**LEE COUNTY HISTORIC PRESERVATION BOARD
OLD LEE COUNTY COURTHOUSE
2120 MAIN STREET
FORT MYERS, FL 33901
EAST ROOM**

AGENDA

A. COA 2011-00167 Wilson Residence, 16281 Quail Trail, Bokeelia, FL 33922

B. COA2011-00111, Goldpenny, 4725 Pine Island Rd, NW, Matlacha, FL 33993

Goldpenny Residence
NEW ELEVATIONS & SITE PLAN

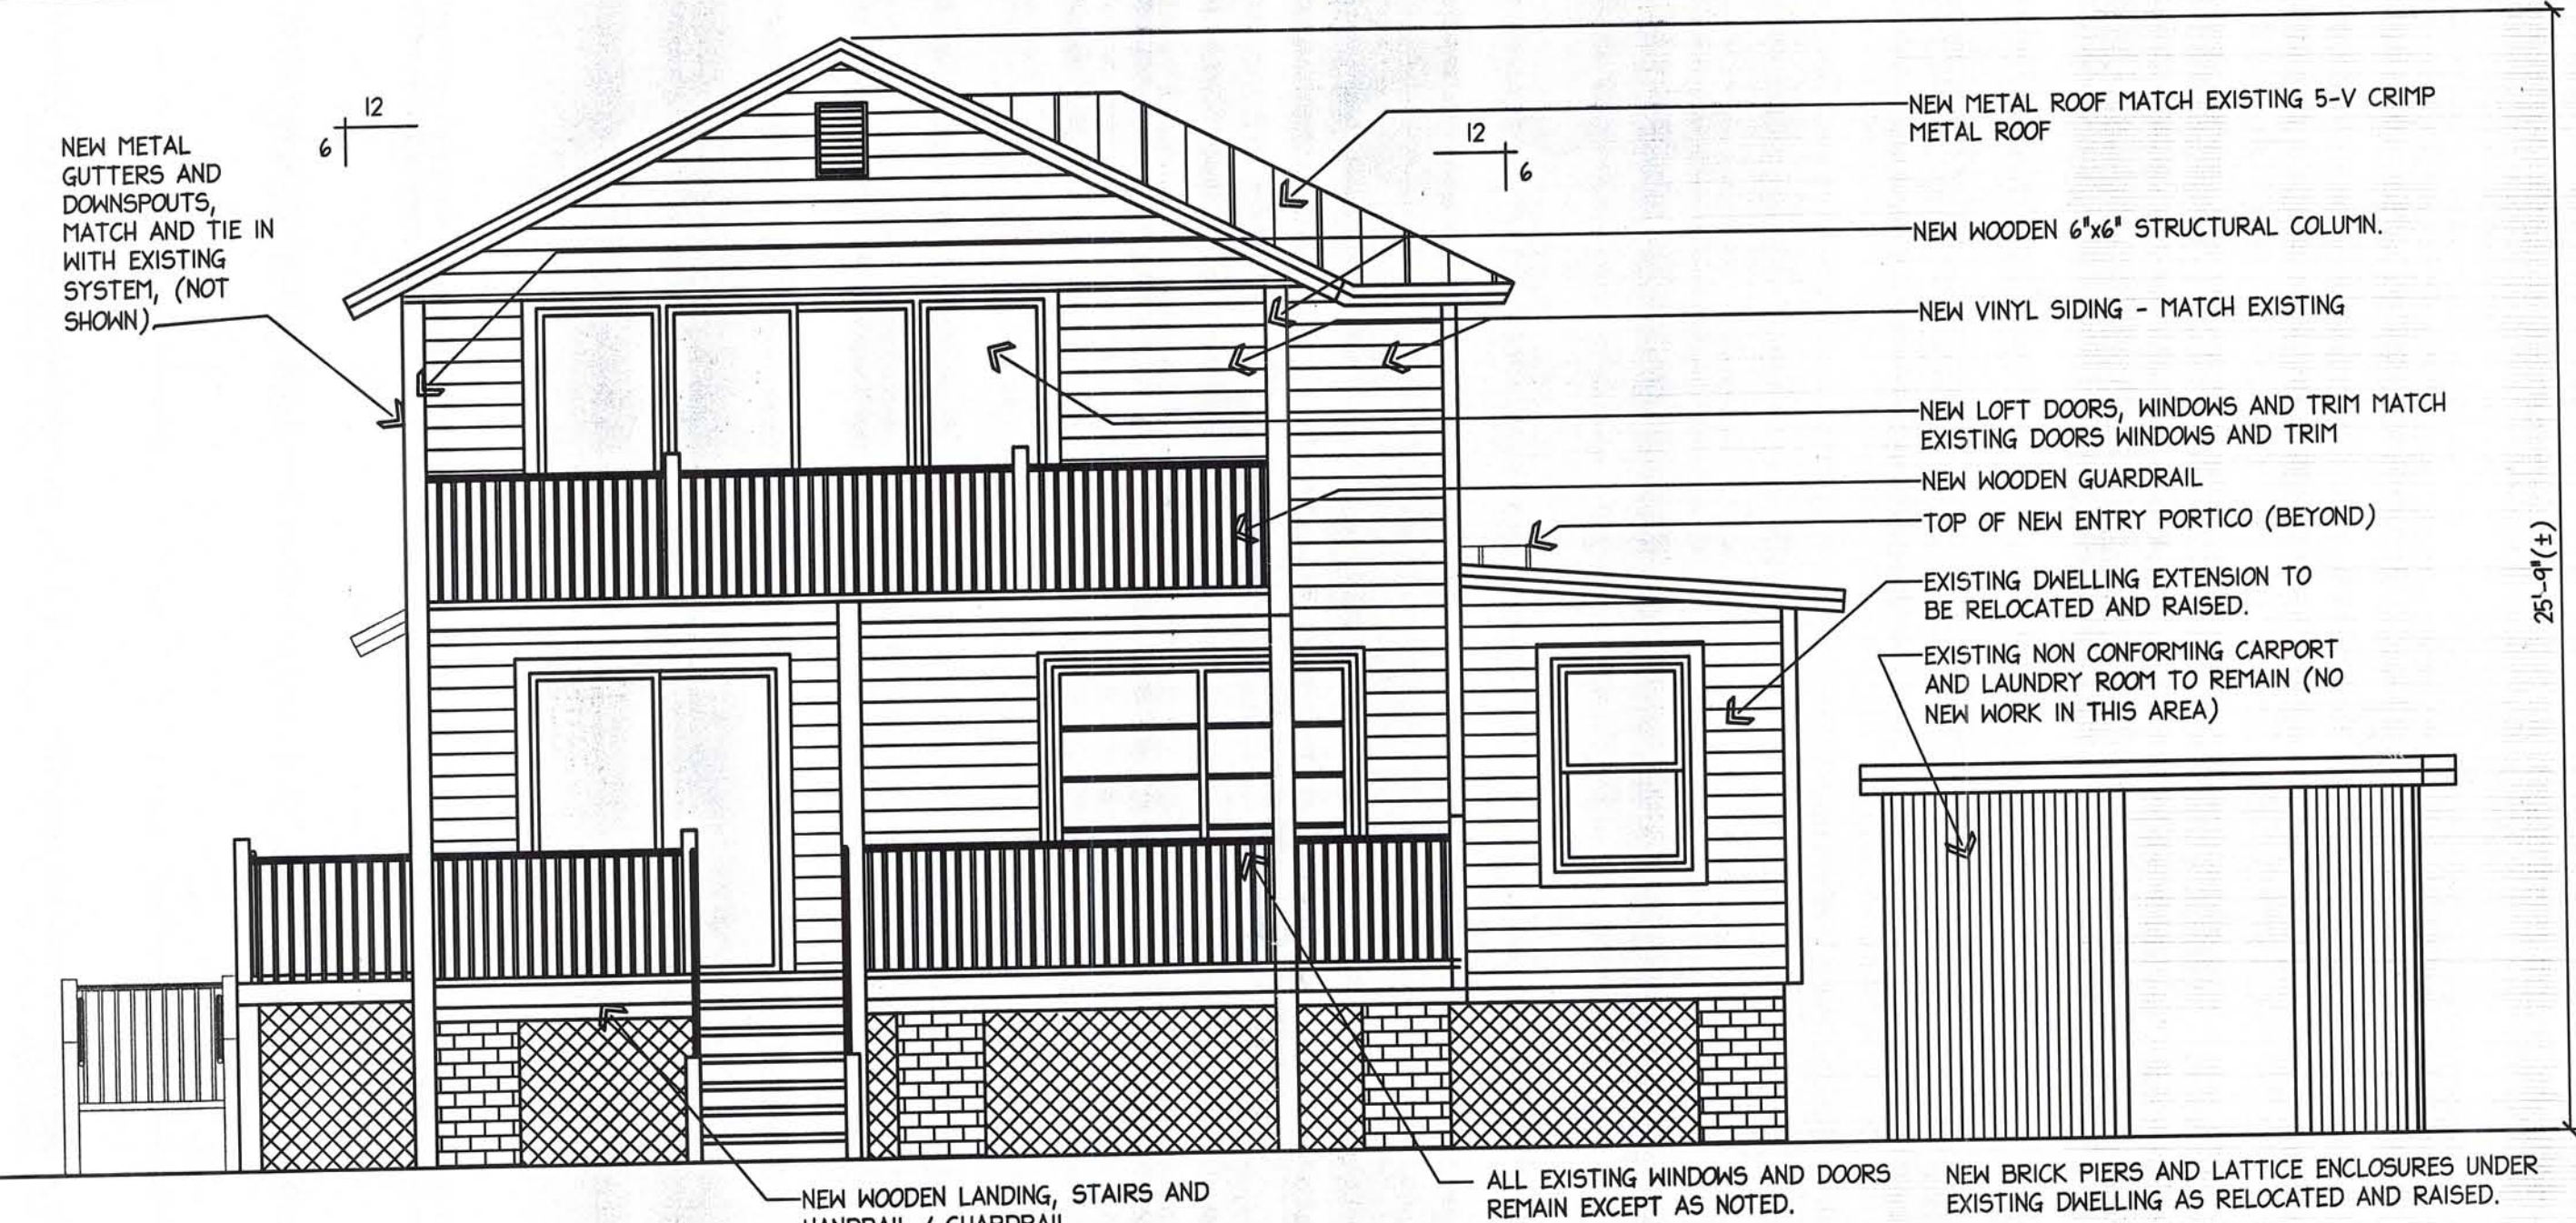
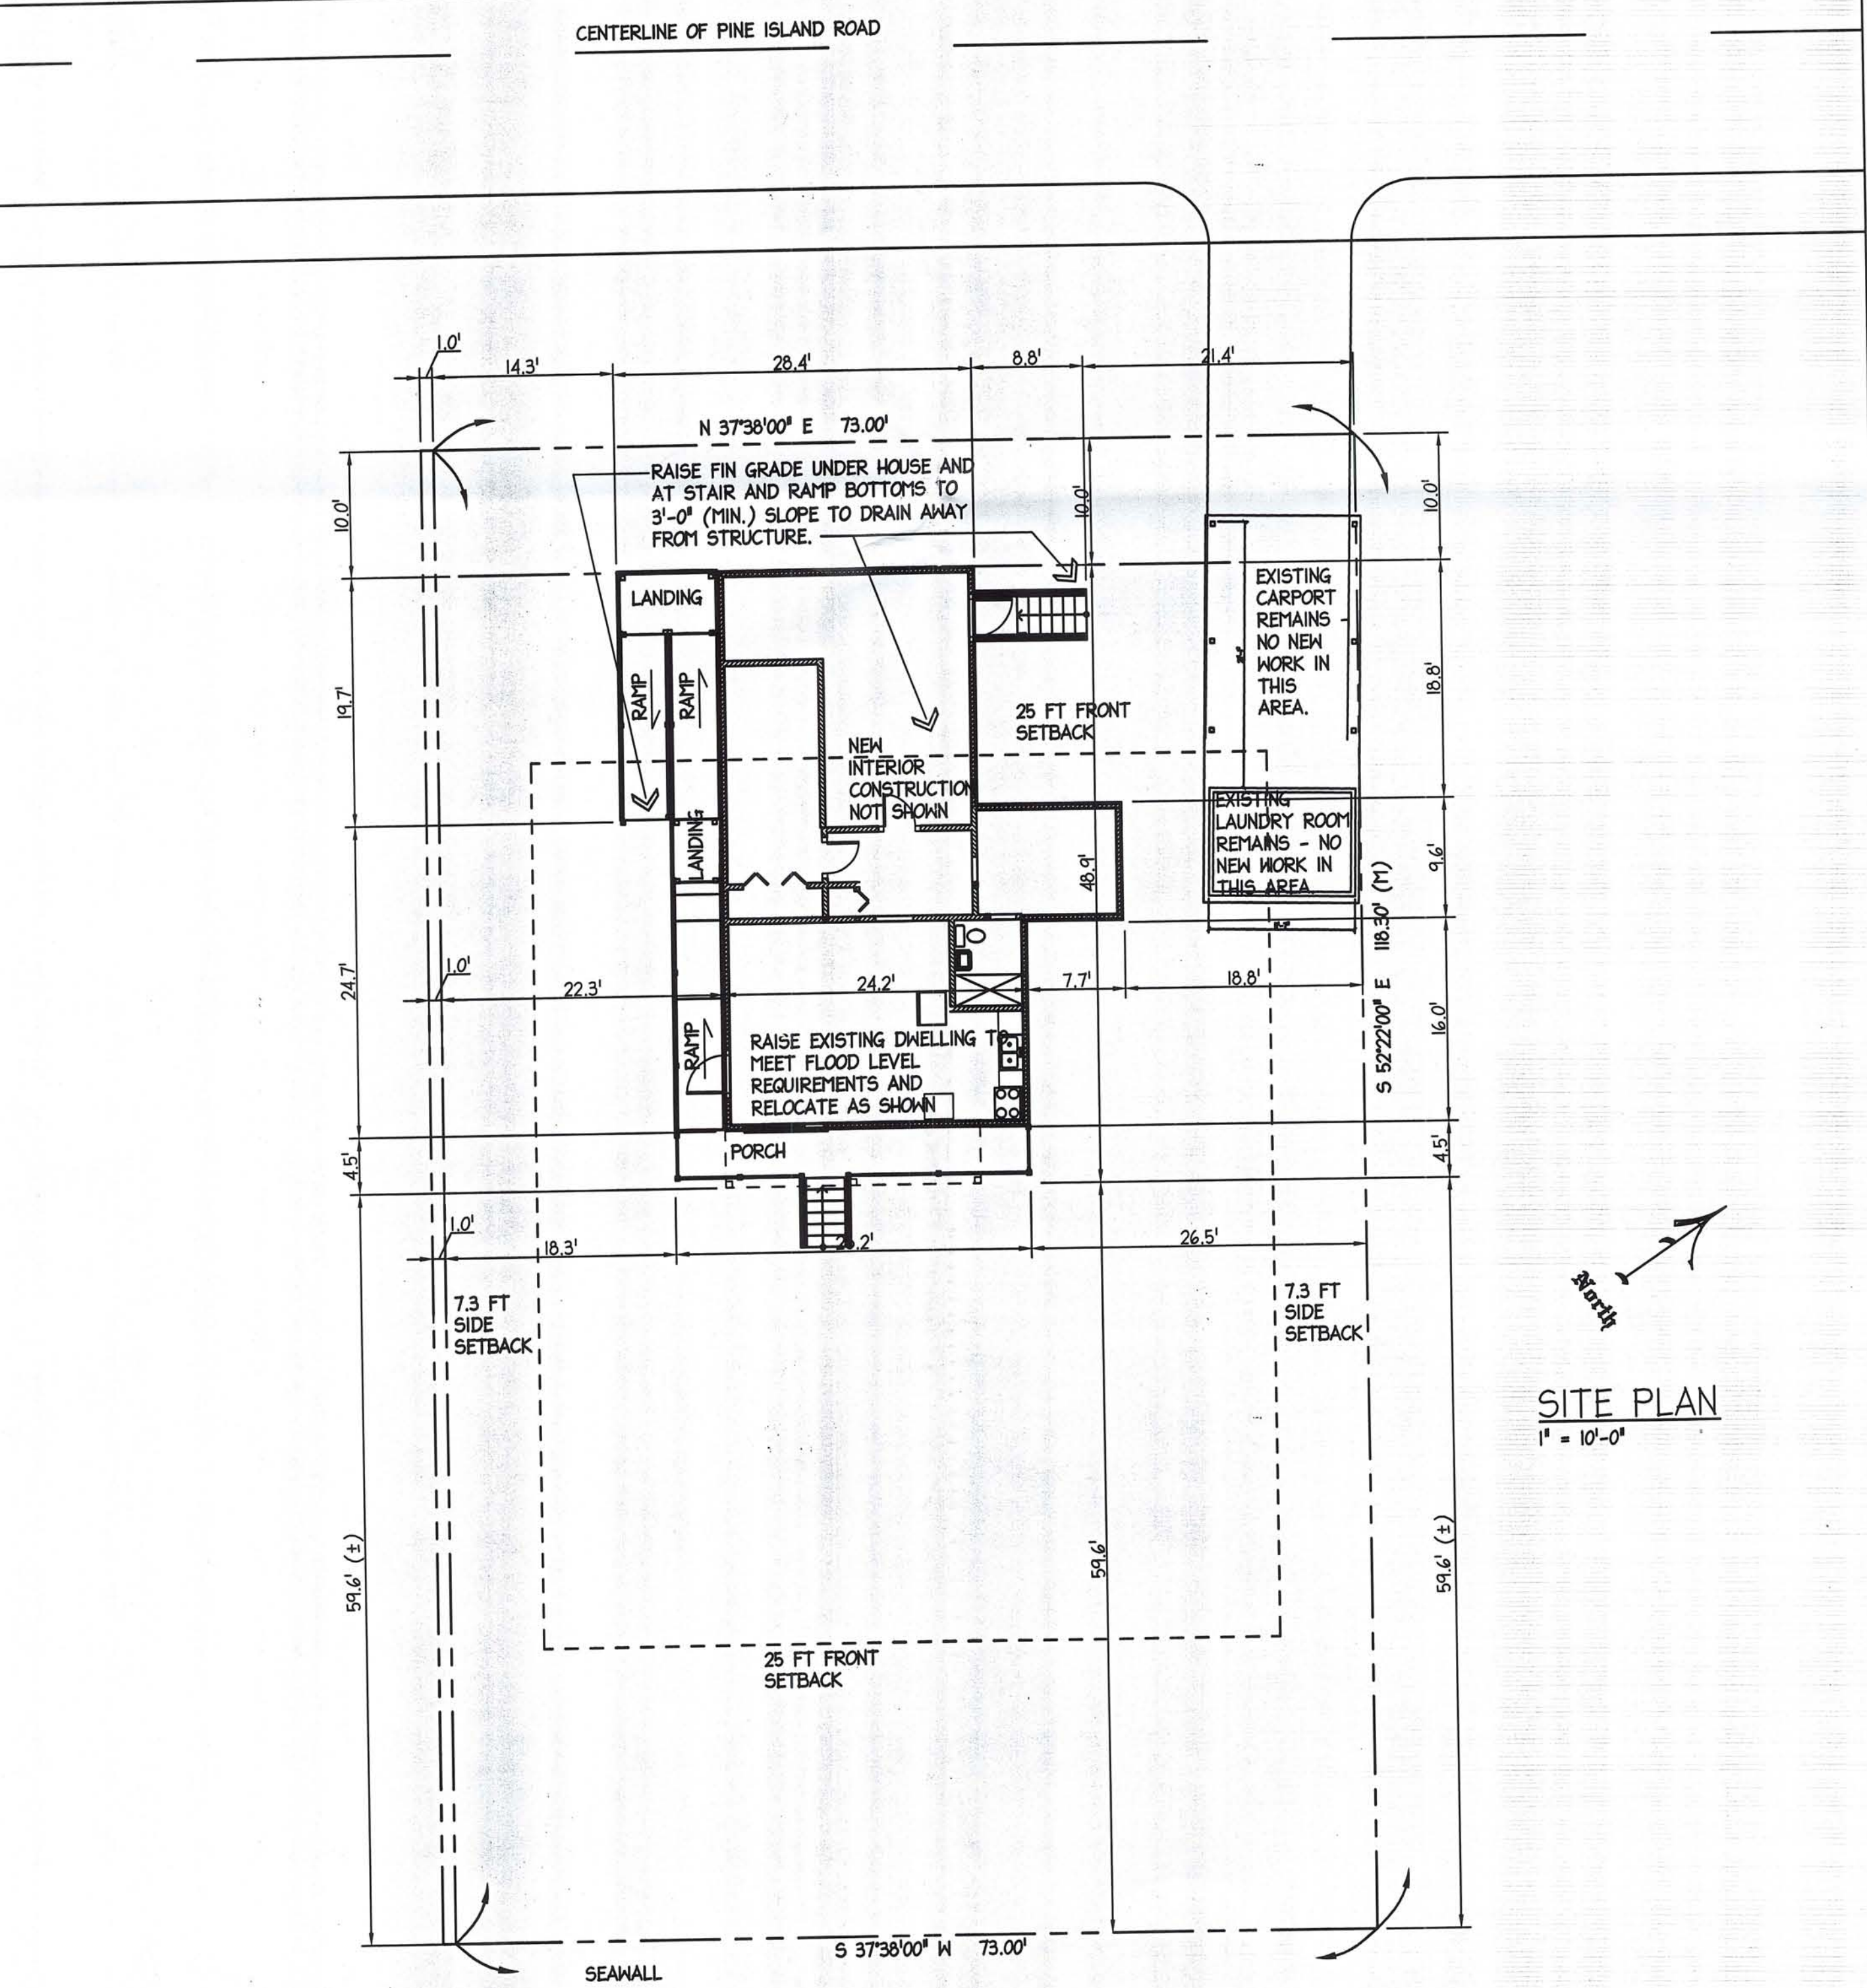
1. Relocation of the house on the site to increase the front setback area. Currently the house has a roughly 2-ft setback from the front property line along Pine Island Rd. The proposal would relocate the entire house as is and increase the setback from the front property line to 10-ft. The new increased setback would be in line with the setback of the adjoining property to the north. A larger front setback area would provide a greater, safer buffer between the house and Pine Island Rd. Safety is a consideration particularly given that the house will have to be handicap accessible. Staff supports this change.

2. Elevating the house from roughly 1-ft 2-in above grade to 4-ft 4-in above grade in order to meet flood elevation. The request is to raise the house by 3-ft 2-in above the current elevation. This would provide greater protection in case of flooding and make the house compliant with flood regulations – which would make it easier and less costly to obtain insurance. Most of the houses along Pine Island Rd in the Matlacha are at or a few feet above grade. Raising the house 3-ft 2-in is a relatively small increase. Overall the height of the house would still be in keeping with the height of other houses in the district and the house would have added protection from flood waters. The proposed change would increase the height of the house from roughly 14-ft 11-in from grade to roof peak to roughly 18-ft 1-in (or increase it from roughly 13-ft 9-in from finished floor to roof peak to roughly 16-ft 11-in)

The elevated house would feature new brick foundation piers with lattice infill between the piers. This type of foundation design is typical of the vernacular houses found in Lee County and in Matlacha. Due to the installation of the handicap ramp (see below) the door towards the rear on the south side will be removed and replaced with a window. Staff supports this change.

While the applicant has tried to minimize the impact of the second floor addition, staff objects to the addition because it will substantially alter the massing, size and scale of the building. The house is a small single story building which at some point in time had slight additions to the rear and north side elevations. Adding a second story would radically change the original design of the building.

There is no compelling reason to add a second story to the building. The house sits on one of the larger lots in the Matlacha Historic District and the house could easily be enlarged by 401 sq ft by placing an addition at the first floor level.

The second floor addition at the rear is not recommended for approval as it involves not a minimal change but a drastic change to the single story design of the house, which is a defining characteristic of the building. Also the addition of a second story would be a substantial change to the environment of the building. The environment of this building is the Matlacha Historic District along Pine Island Road and in the vicinity of the subject property. (See attached photographs) This area of the district predominantly composed of small, single story buildings. This proposal does not meet this standard.
